Subject: AP1000 COL Responses to Requests for Additional Information (TR 143)

Westinghouse is submitting responses to the NRC requests for additional information (RAIs) on AP1000 Standard Combined License Technical Report 143, APP-GW-GLN-143, "Evaluation of the Effect of Shield Building Changes on Containment Response and Safety Analyses". These RAI responses are submitted in support of the AP1000 Design Certification Amendment Application (Docket No. 52-006). The information included in the responses is generic and is expected to apply to all COL applications referencing the AP1000 Design Certification and the AP1000 Design Certification Amendment Application.

AP1000 TECHNICAL REPORT REVIEW

Figure 1: Revision 0 Shield Building Roof Elevations

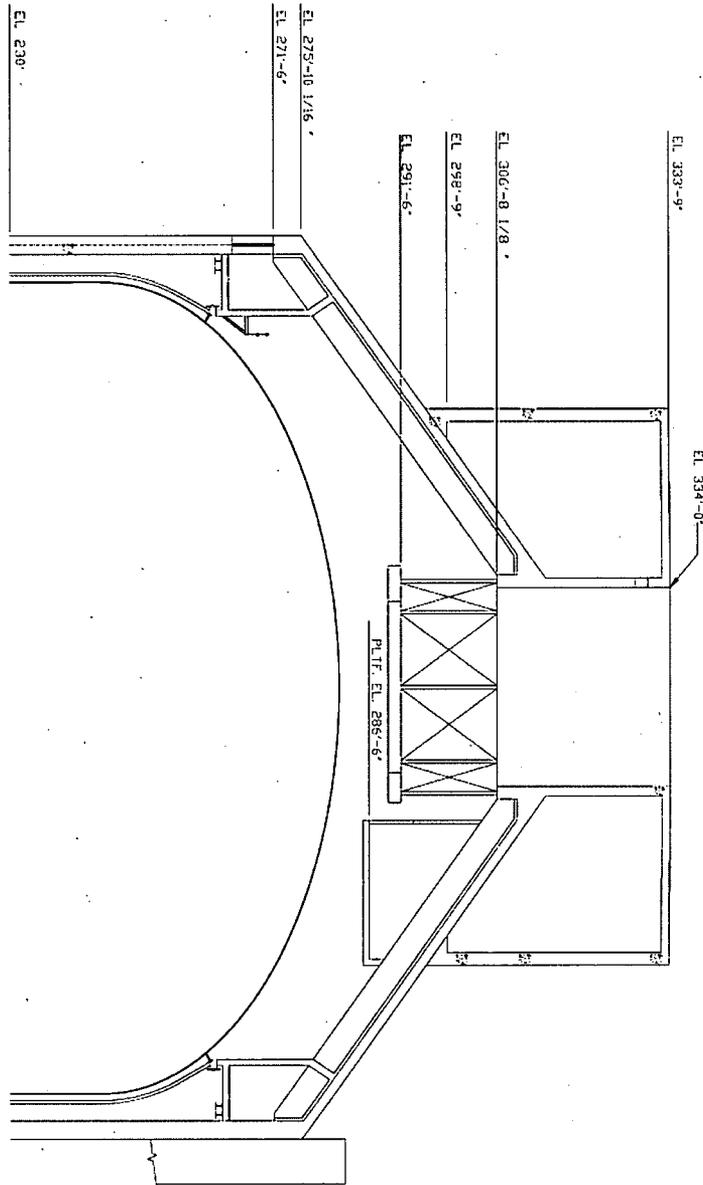
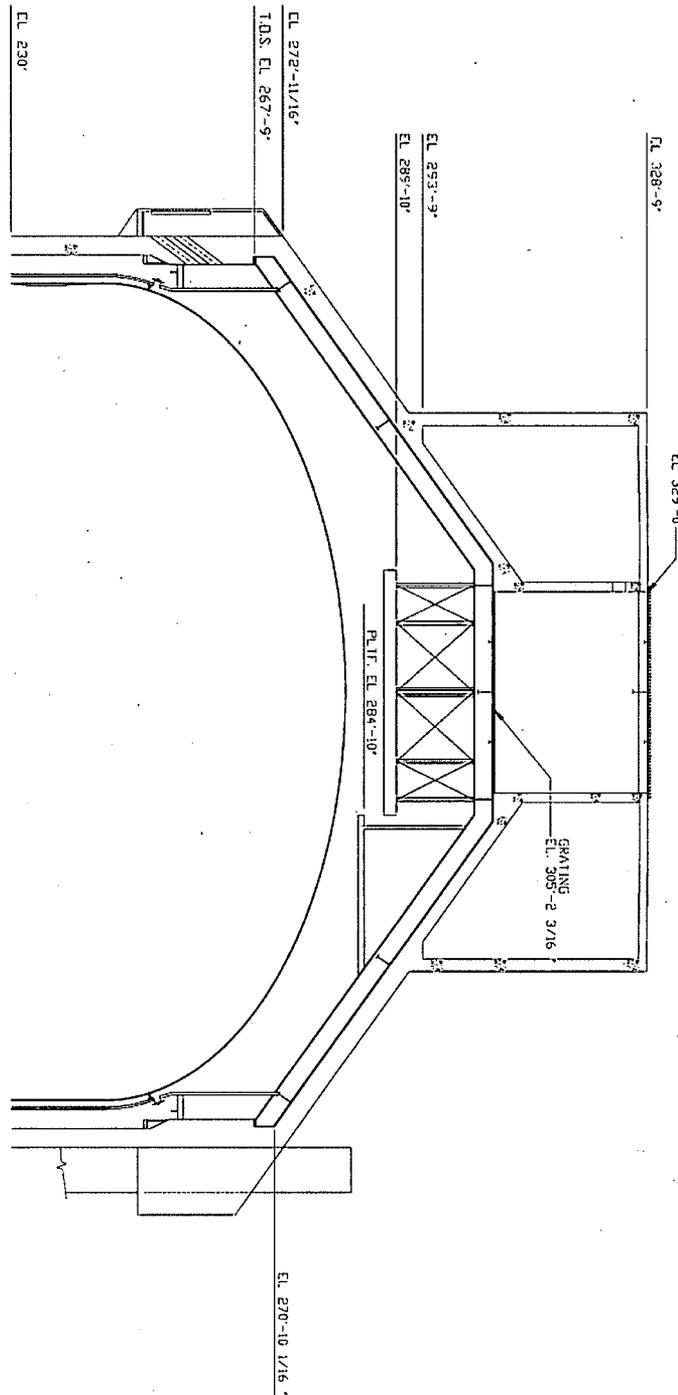
Page 5 describes changes to the shield building from the original DCD design which the staff reviewed and approved. Specifically, the changes to the air inlet structure and a reduction in the height of the shield building. Appendix A provides a detailed description of the changes to the air inlet structure. Please provide a similar description showing how the 5-foot reduction in shield building height was accomplished including the location on the section where the height reduction was implemented.

The 5-foot reduction refers to a change in overall height at the maximum elevation of the shield building. The overall height reduction, as well as other modifications, imposes various elevation changes. Figure 1 and Figure 2 show key elevations for revision 0 and revision 1 of the shield building roof. Elevation 230' is provided as reference location to show how the reduction was accomplished. The Shield Building design changes are described in detail with justification in APP-GW-GLN-105 (Technical Report 105). Please refer to page 16 of 259 in Technical Report 105.

Figure 1: Peak Containment Pressure for LOCA vs. Inlet Blockage

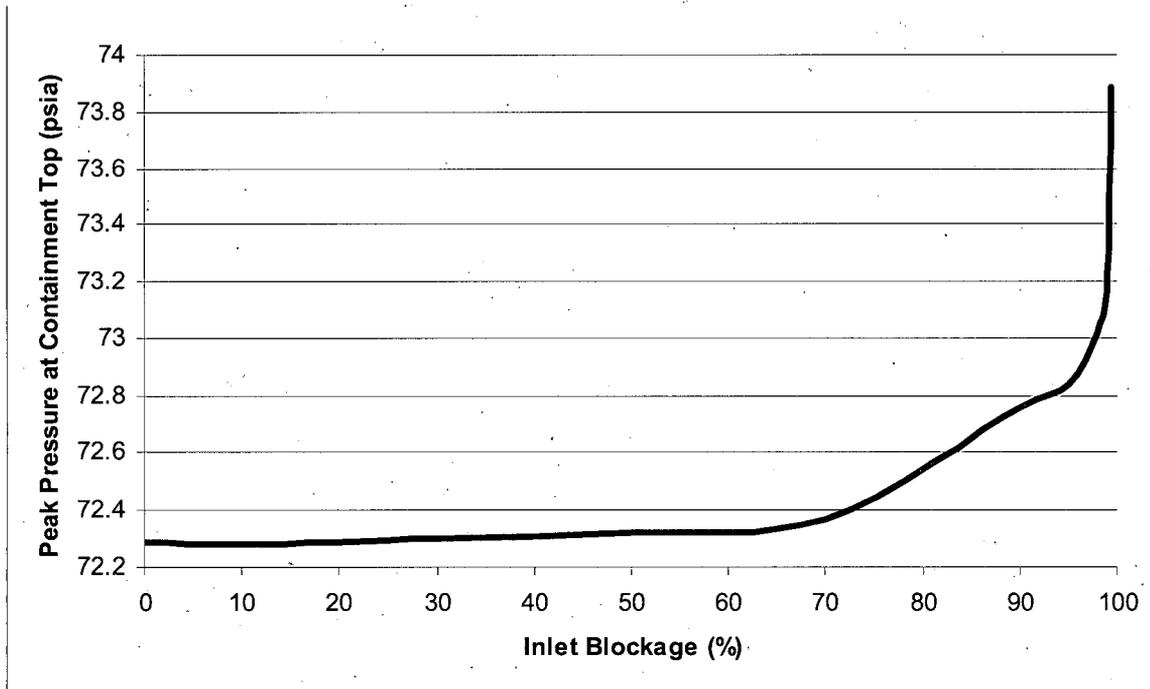
On page 17 of APP-GW-GLN-105 it is stated that: previous analyses were performed to show that blockage of a significant fraction of the air inlets (in the old design) could occur without significantly affecting the PCS performance provided water application is assured. Please provide a reference obtainable to the staff for these analyses.

The blockage analysis was performed on the previous shield building design. The containment pressure response to a design basis LOCA event was predicted using WGOTHIC. The inlet area was varied to determine the sensitivity of the peak pressure to the percent blockage. The results showed that for any design basis event, the PCS water is assumed to be available and the peak pressure is insensitive to the flow blockage until the inlets are nearly totally blocked. The peak pressure as a function of inlet blockage is shown in Figure 1, and the Passive Containment Cooling System air flow as a function of inlet blockage is shown in Figure 2.

The reference for this analysis is APP-SSAR-GSC-680 which has been made available for NRC review at the Westinghouse Rockville office.
